ZTE CORPORATION

Change Description

FCCID : SRQ-Z6251

Model : Z6521

Figure 1-1. High-level MT6762D functional block diagram

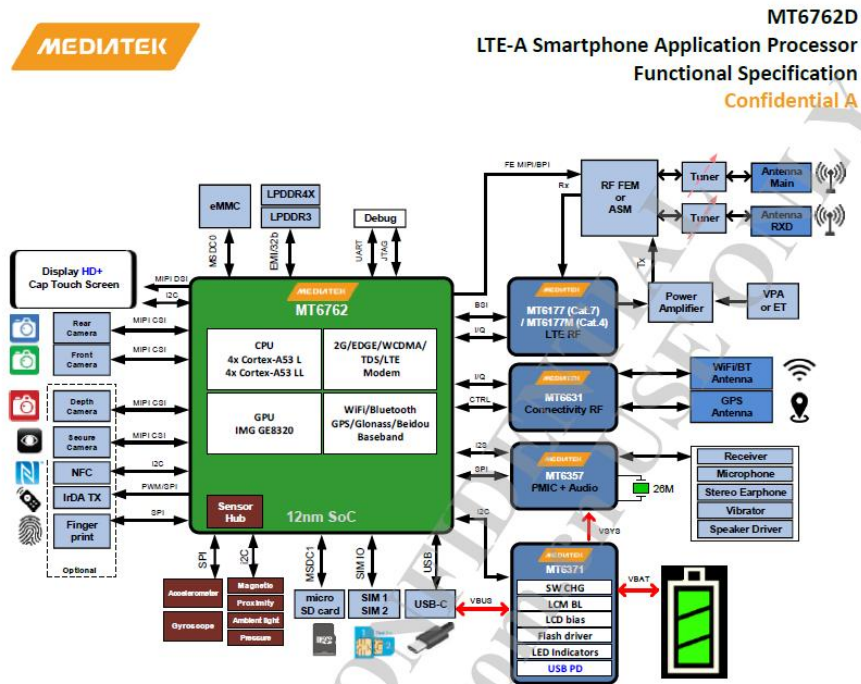
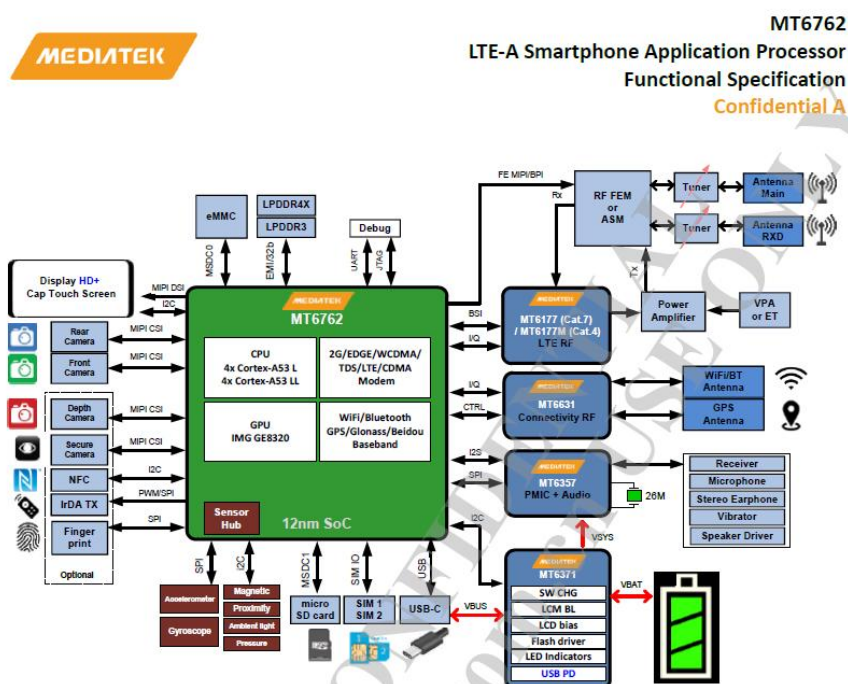
Patent Chip	Variant Chip
Model	MT6762V/WA	MT6762V/CA
Hardware changes	No Changes	
Software changes 1	5-mode cat4	6-mode cat4 (add the CDMA mode)
Software changes 2	Cortex-A53 1.8GHz	Cortex-A53 2GHz
Software changes 3	LPDDR4X 4GB	LPDDR4X 6GB or 8GB?
Software changes 4	LTE Cat4(150M)	LTE Cat7(300M)
Block diagram	As follows

Patent Chip: MT6762V/WA -> MT6762V/CA

Variant Chip: MT6762V/WA -> MT6762V/CA
